SUBJECT: COMANCHE PEAK STEAM ELECTRIC STATION, UNITS 1 AND 2 -
AMENDMENT NOS. 63 AND 49 TO FACILITY OPERATING LICENSE
NOS. NPF-87 AND NPF-89 (TAC NOS. MA4204 AND MA4205)

SAFETY EVALUATION BY THE OFFICE OF NUCLEAR REACTOR REGULATION

COMANCHE PEAK STEAM ELECTRIC STATION, UNITS 1 AND 2

FIGURE 2.1-1b
UNIT 2 REACTOR CORE SAFETY LIMITS

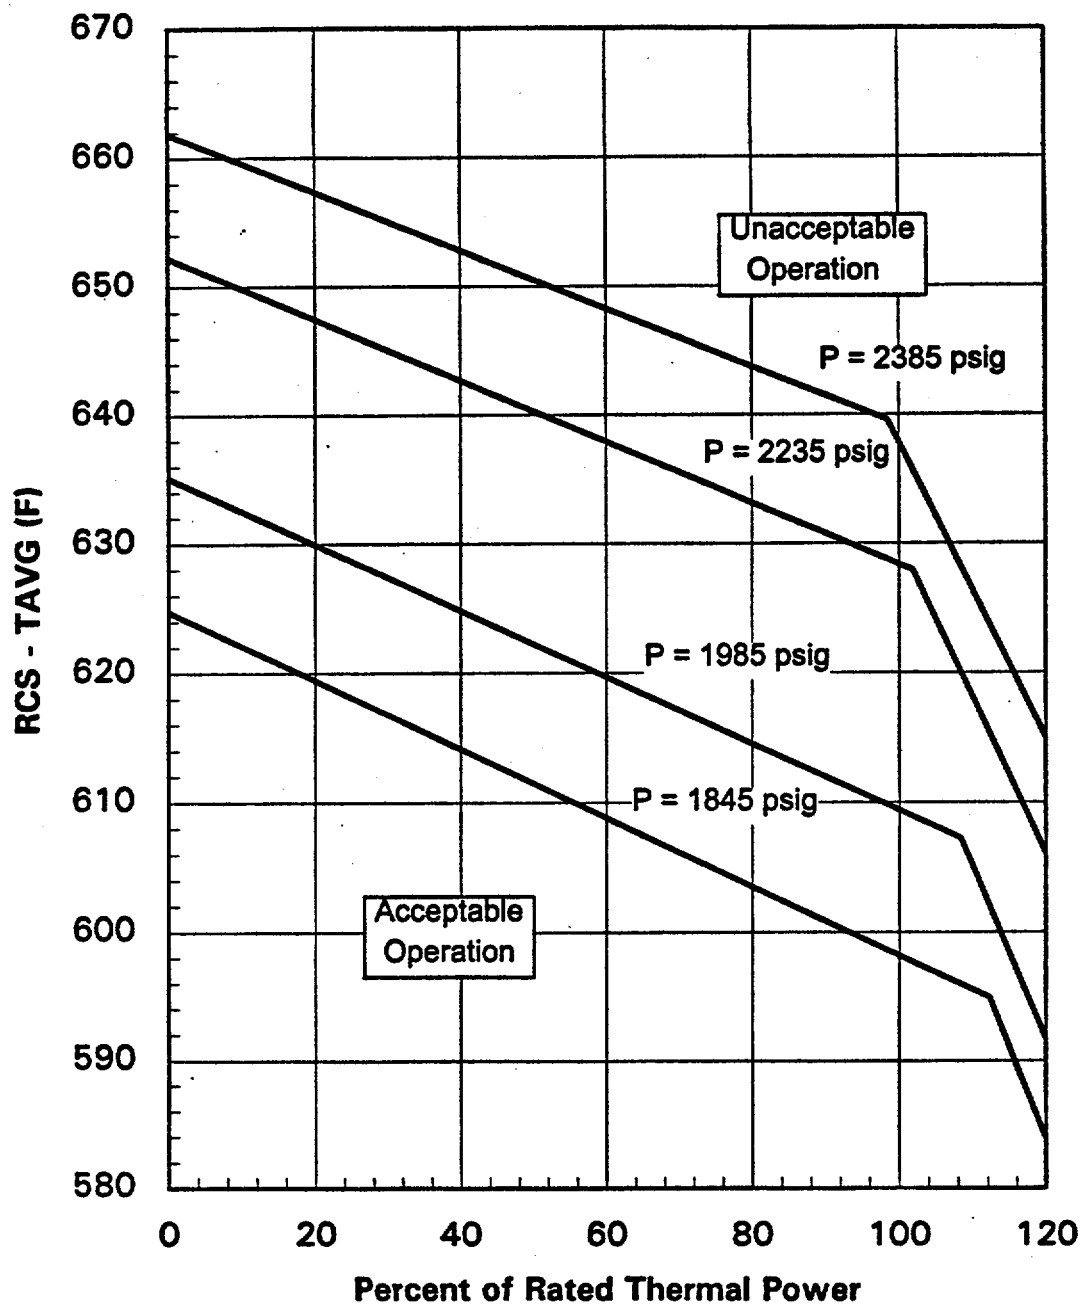
The licensee indicated that they used NRC-approved methodologies as stated in TS 6.9.1.6b Items 9 through 14 to determine the new reactor core safety limit curves for Unit 2, TS Figure 2.1-1b. The resultant core safety limit curves were evaluated by NRC-approved analytical methods to determine the appropriate values of K_1 , K_2 , and K_3 , coefficients of the overtemperature setpoint and the $f(\Delta I)$ trip reset functions as noted below:

The licensee has requested to change TS Figure 2.1-1b, Unit 2 Reactor Core Safety Limits and TS Table 2.2-1, "Reactor Trip System Instrumentation Trip Setpoints," Units 1 and 2 to accommodate changes due to the designed core configuration for Unit 2, Cycle 5. The staff has reviewed the changes to verify that all safety criteria have been satisfied. The proposed revisions to the safety limit curves and the trip setpoints, and the use of NRC-approved

methodologies will provide assurance of DNB margin. Therefore, the staff finds the licensee's requested changes acceptable.
